# Access Compliance Report

## Public Rights-of-Way

### (Curb Ramps)

Intersection ID: 47463	Main Street: DOMINION_VILLAGE_DR	Cross Street: DOMINION_GREEN_DR	Location: SE
ADA ID: 2575D7D42C12	Ramp Type: BlendTrans1	Initial Pass/Fail: Fail	Overall Compliance: No
		Severity Score: 10

#### Codes/Mitigation Info/Possible Solution

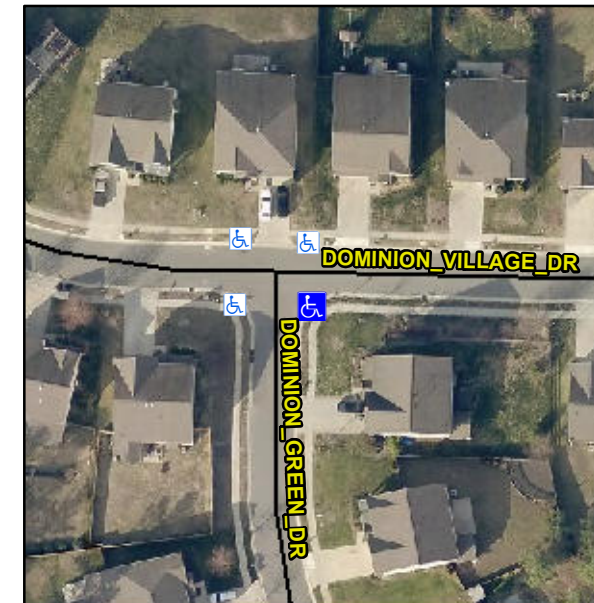
**Not Found, R304.5.1, R304.5.3**

Compliance	Description	Data	Compliance	Description	Data
N/A	Ramp Length (in)	48.0	Yes	BlendTrans Slope (%)	2.4
No	Ramp Width (in)	46.5	No	BlendTrans XSlope (%)	5.0
N/A	Flare Type LT	Sloped	N/A	Flare Type RT	Sloped
N/A	Flare Slope LT (%)	0.3	N/A	Flare Slope RT (%)	9.6
N/A	Flare Traversable LT?	No	N/A	Flare Traversable RT?	No
N/A	Landing Length (in)	47.5	N/A	DWS Provided?	Yes
N/A	Landing Width (in)	46.5	N/A	DWS Contrast?	Yes
N/A	Landing Slope (%)	2.5	N/A	DWS Length (in)	48.0
N/A	Landing X Slope (%)	2.4	N/A	DWS Full Width?	Yes
N/A	Landing Curb? (Y/N)	No	N/A	DWS Offset (in)	5.5
N/A	Shared Landing?	No			
N/A	Gutter Ponding?	No	N/A	Gutter Slope (%)	5.5
N/A	Gutter Lip Ht (in)	0.3	N/A	Gutter X Slope (%)	3.8
N/A	Painted X Walk1?	No	N/A	Painted X Walk2?	No
	X Walk 1 Direction	To N		X Walk 2 Direction	To W
	X Walk 1 Width (in)	N/A		X Walk 2 Width (in)	N/A
	X Walk 1 Slope (%)	2.1		X Walk 2 Slope (%)	6.9
	X Walk 1 X Slope (%)	6.6		X Walk 2 X Slope (%)	3.6

N/A	Ramp inside XWalk1?	N/A	N/A	Ramp inside XWalk2?	N/A
	Road Slope (%)	3.6		Clear Space?	Yes
	Road X Slope (%)	5.2	N/A	Clear Space to XWalk (in)	N/A
N/A	Any Obstructions?	No	N/A	Storm Grate/Utility Hazard?	No
	Obstruction Type			Storm Grate/Utility Type	
		N/A			N/A
			Yes	Surface Condition? (G/P)	Good
			No	Curb Slope (%)	12.2

**Remove & Replace Curb Ramp With Two New Directional Ramps or Equivalent.**
